**SECTION 16 APPLICATION
 TOWN PLANNING ORDINANCE (CHAPTER 131)**

**PROPOSED SOCIAL WELFARE FACILITY (RESIDENTIAL CARE HOME FOR THE ELDERLY) IN
 "VILLAGE TYPE DEVELOPMENT" ZONE ON APPROVED NAM SANG WAI OUTLINE ZONING
 PLAN NO. S/YL-NSW/10 AT LOTS 3670 RP (PART), 3671 RP (PART), 3672 RP (PART) AND 3673
 RP (PART) IN D.D.104, NAM SANG WAI, YUEN LONG**

Town Planning Application No. A/YL-NSW/349 - Submission of Further Information (6)

Response-to-Comment Table

— 1 —

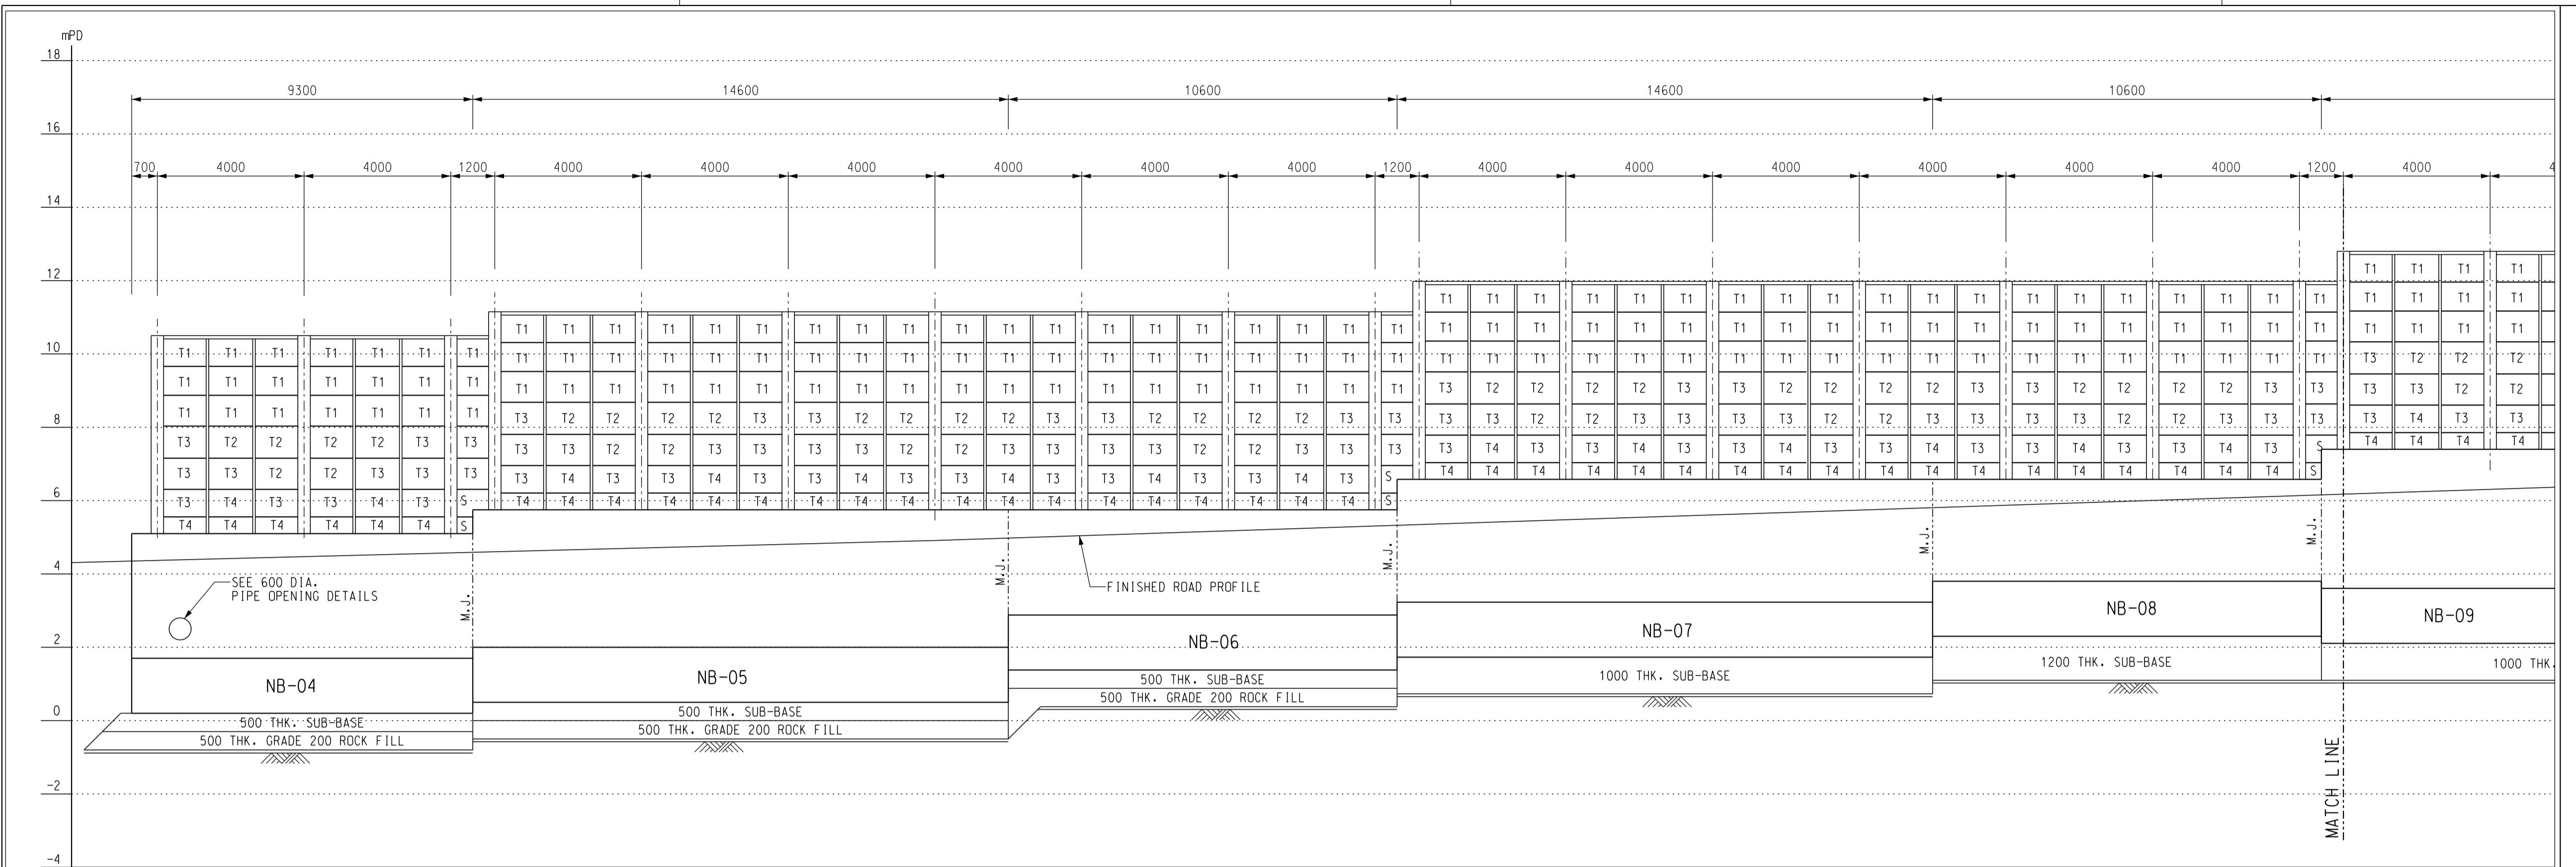
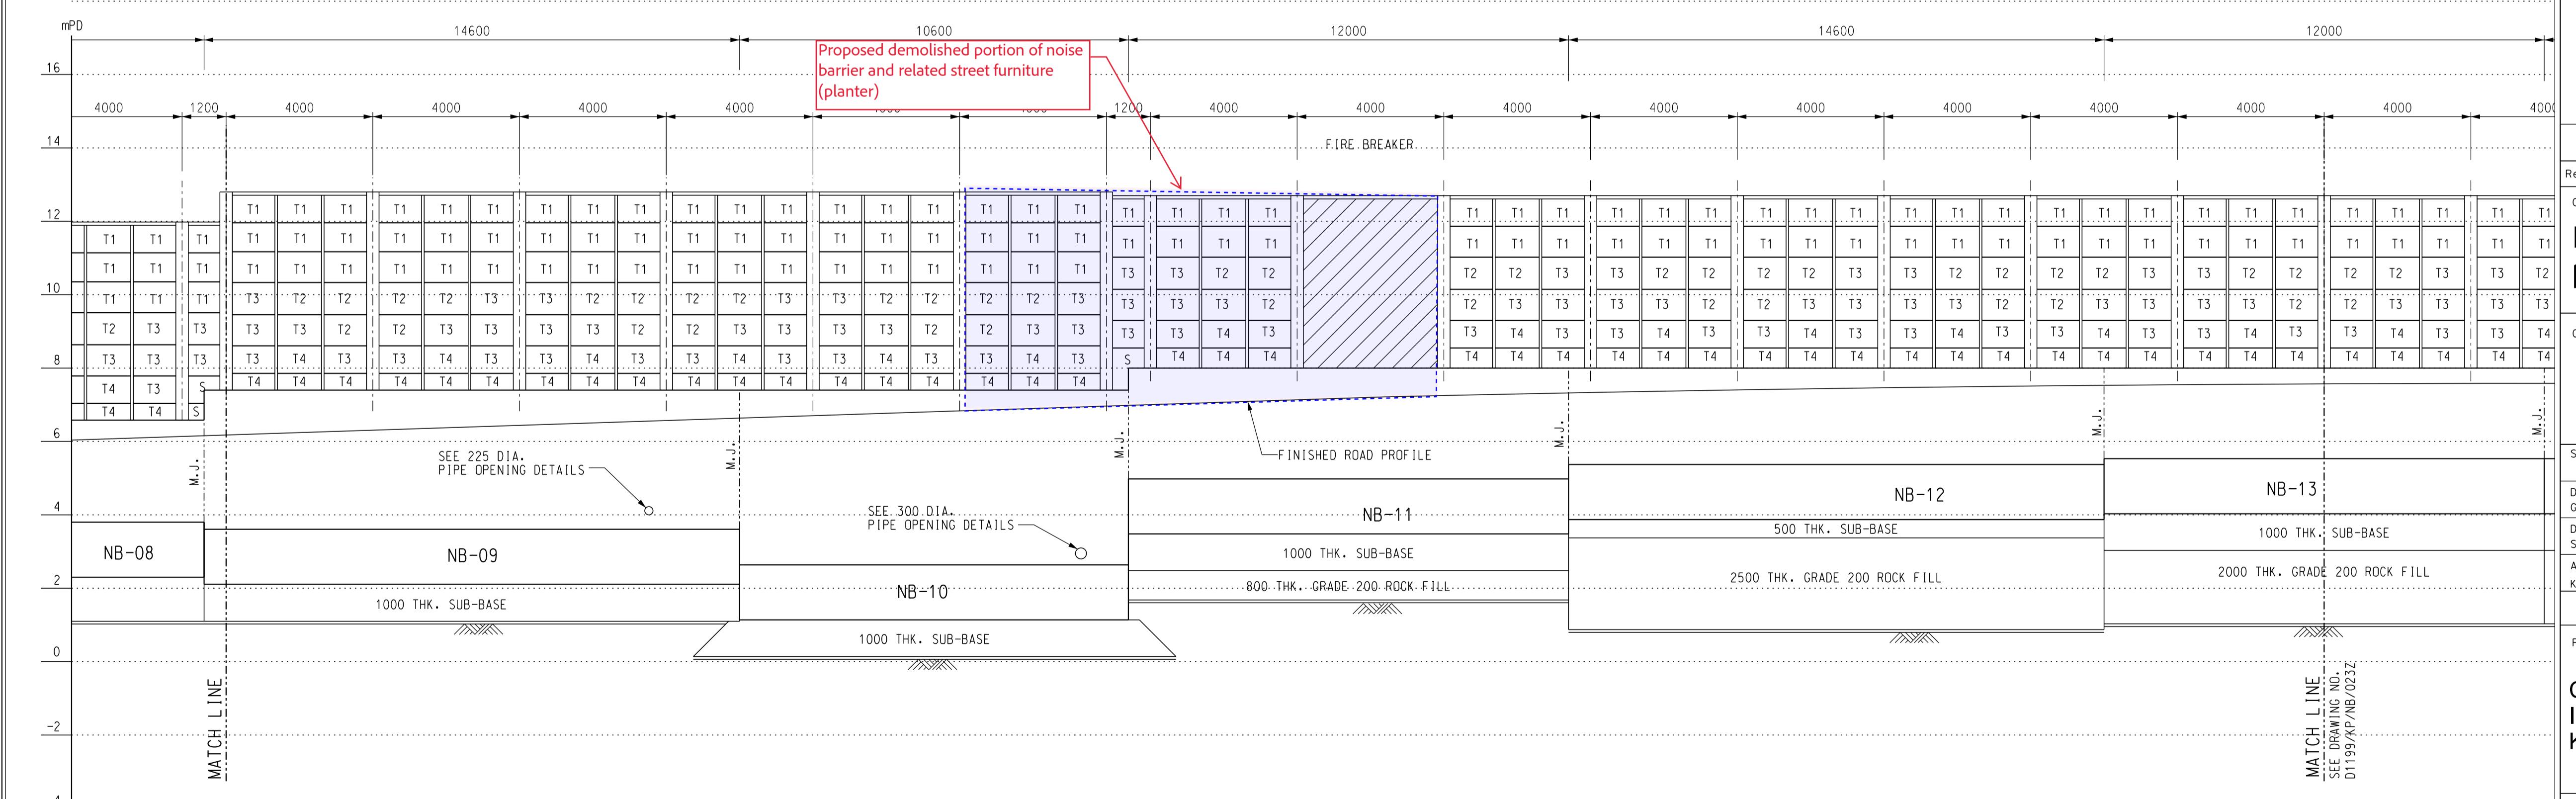
1. Noise Please supplement in the report the reason(s) for the proposed demolition of the existing noise barrier.	See revised Environmental Assessment (Appendix 2). The discussion is provided in Section 3.4.7.

3.	<p>It is noted that the applicant proposes to modify an existing noise barrier for construction of access roads to the application sites. As such, for the sake of completeness, (a) the road traffic noise impact on the proposed development and nearby noise sensitive receivers (NSRs) due the modification of the noise barrier should be addressed and (b) schedule of implementation, for example, to remove the noise barrier only after the RCHD and RCHE are in place, or to provide interim measures (if required) to mitigate road traffic noise impact to nearby NSRs should be provided in the noise impact assessments in the updated EAs. Also, the applicant should (c) provide TD's endorsement on the traffic data adopted in the updated NIAs and (d) ensure the separated cells of the dormitory should not be divided by full-height partitions.</p>	Noted with thanks.
